Item Name: Fwd Crosstube - Extended Height 31"

DART AEROSPACE LTD	Work Order:	146597
Description: Crosstube High-High Fwd	Part Number:	D205-596-105
Inspection Dwg: D205-596-105 Rev: B		Page 1 of 1

DRAWING NO. D205-596-105	TITLE CROSSTUBE ASS'Y, HI-HI FWD	REV. B	DART AEROSPACE LTD ENGINEERING ORDER		D.E.O. NO. D205-596-105-B-2	SHEET NO. SHEET 1 OF 1	SCALE NTS
DRAWN <i>qp</i>	CHECKED <i>A.P.</i>	MFG. APPR. <i>AS</i>	APPROVED <i>MP</i>		DE APPR. <i>HA</i>		
DATE 13.11.11	DATE 13.11.19	DATE 13.11.19	DATE 13/11/21		DATE 13/11/21

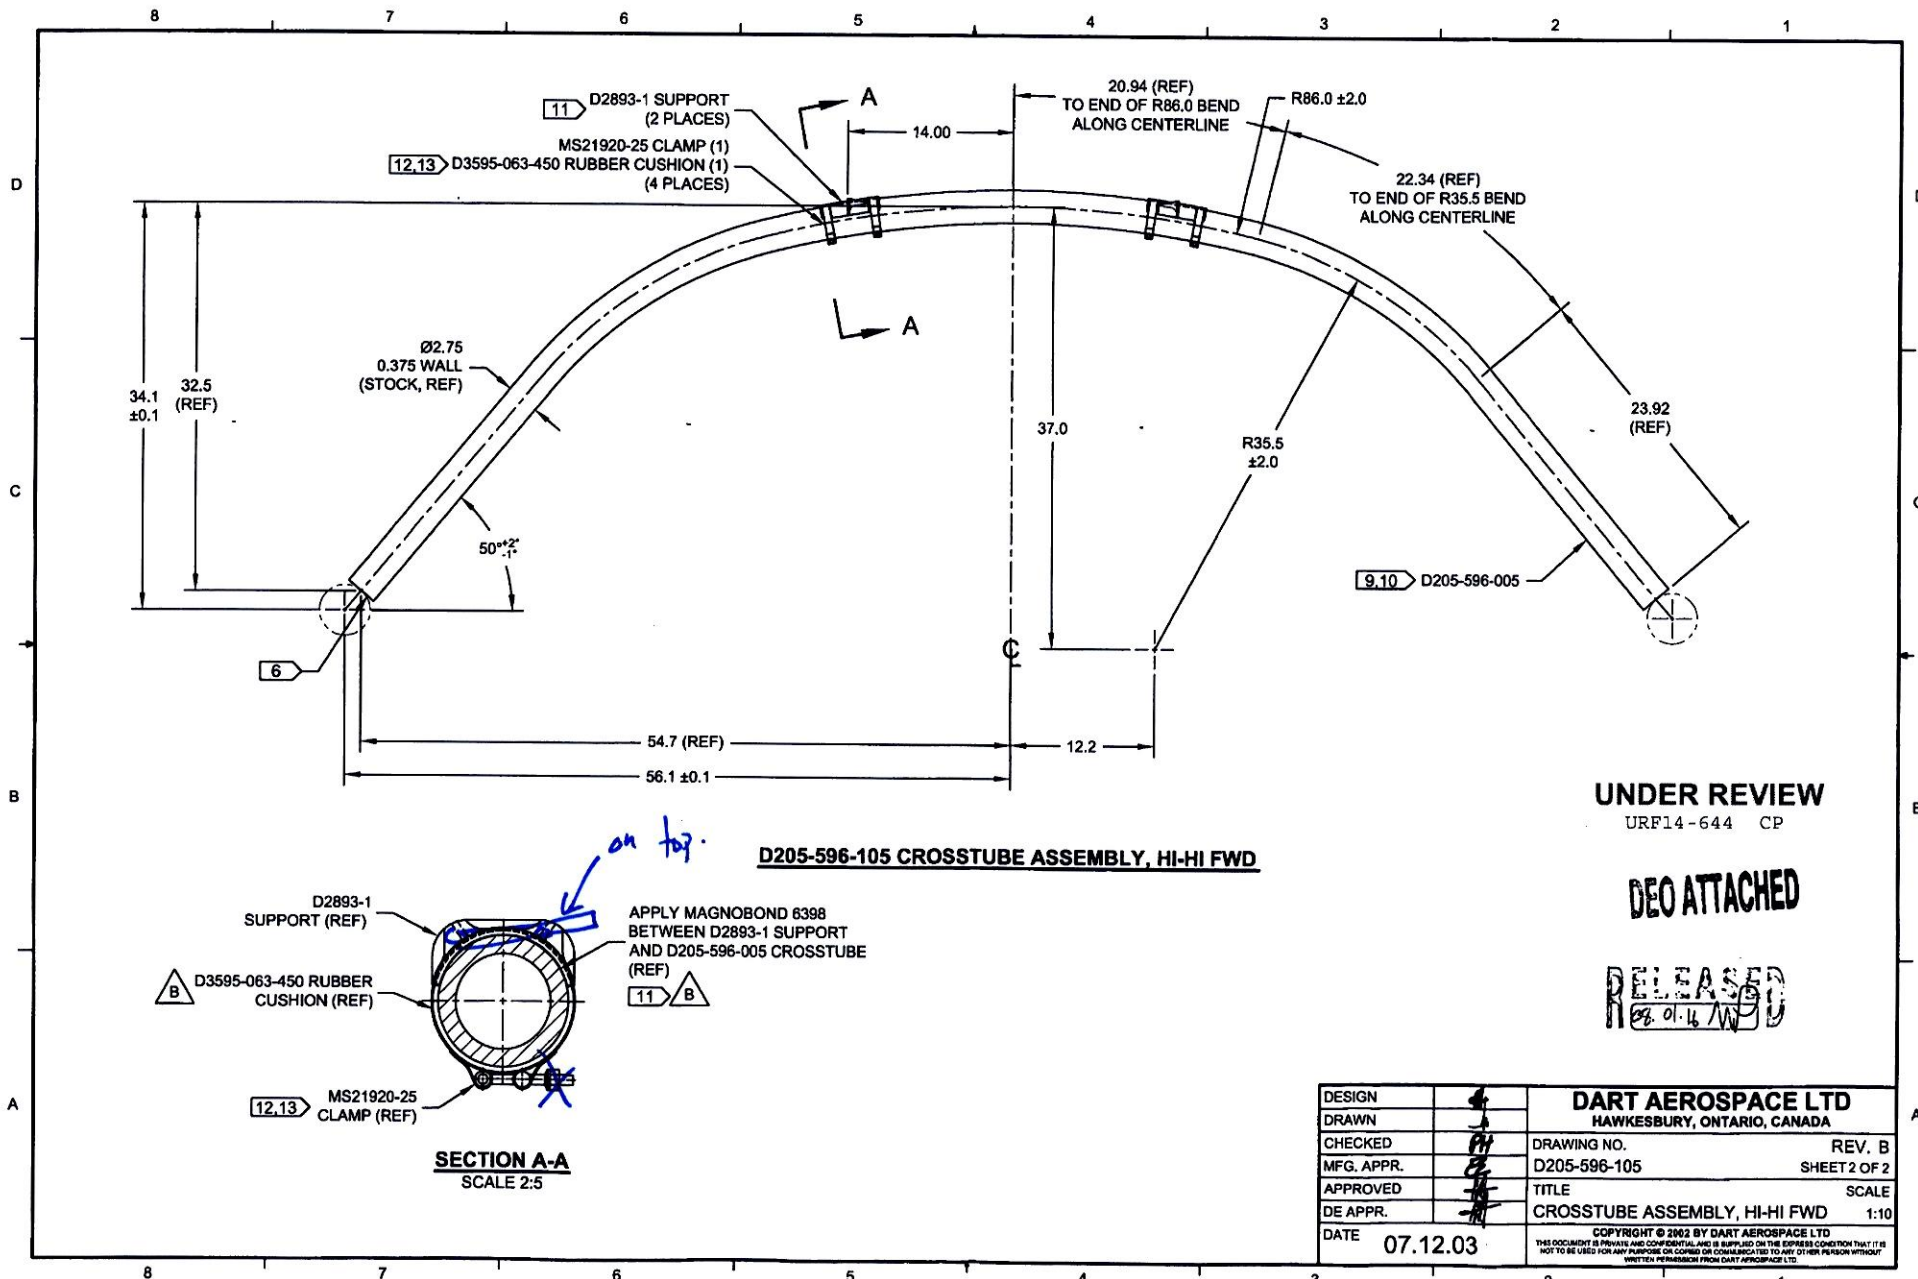
REPLACE MAGNOBOND WITH PROSEAL.

NOTE 11 & 13, SHEET 1 IS AMENDED AS FOLLOWS:

- 11) TO INSTALL D2893-1 SUPPORT: ABRABE MATING SURFACE OF SUPPORT AND CROSSTUBE WITH 180-GRIT SANDPAPER AND REMOVE RESIDUE WITH MEK (OR EQUIVALENT). APPLY A 0.04" TO 0.07" THICK LAYER OF PROSEAL 890 CLASS B-2 (OR AMS-S-8802 CLASS B-2) SEALANT TO MATING SURFACE OF SUPPORT.
- 13) TORQUE CLAMPS 80 TO 100 IN-LB. ENSURE AT LEAST 1.5 THREADS SHOWING IN SAFETY AND THAT NUT HAS NOT BOTTOMED-OUT AFTER TORQUING. **PRIOR TO PACKAGING, RE-CHECK TORQUE ON CLAMPS AFTER PROSEAL 890 SEALANT HAS CURED FOR 72 HOURS.**

- 11) APPLY A 0.03" TO 0.06" THICK LAYER OF MAGNOBOND 6398 TO THE SURFACE OF D2893-1 THAT WILL BE IN CONTACT WITH THE CROSSTUBE. LET CURE FOR 12 HOURS AFTER INSTALLATION AND PRIOR TO PACKAGING.
- 13) TORQUE CLAMPS 80 TO 100 IN-LB.

FIGURE 1 - SUPPORT INSTALLATION

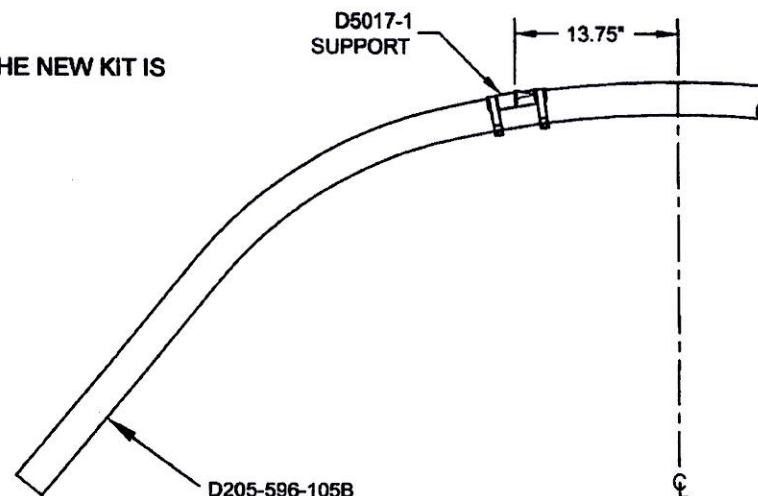
ADD THE FOLLOWING CROSSTUBE ASSEMBLY:

THE D205-596-105B CROSSTUBE HAS THE SAME PARTS LIST AS THE D205-596-105 CROSSTUBE EXCEPT AS FOLLOWS:

2	D5017-1	SUPPORT
---	---------	---------

2	D2893-1	SUPPORT
---	---------	---------

INSTALL THE SUPPORTS AS SHOWN IN FIGURE 1 OF THIS ENGINEERING ORDER. THE NEW KIT IS OTHERWISE ASSEMBLED PER THE D205-596-105 CROSSTUBE.
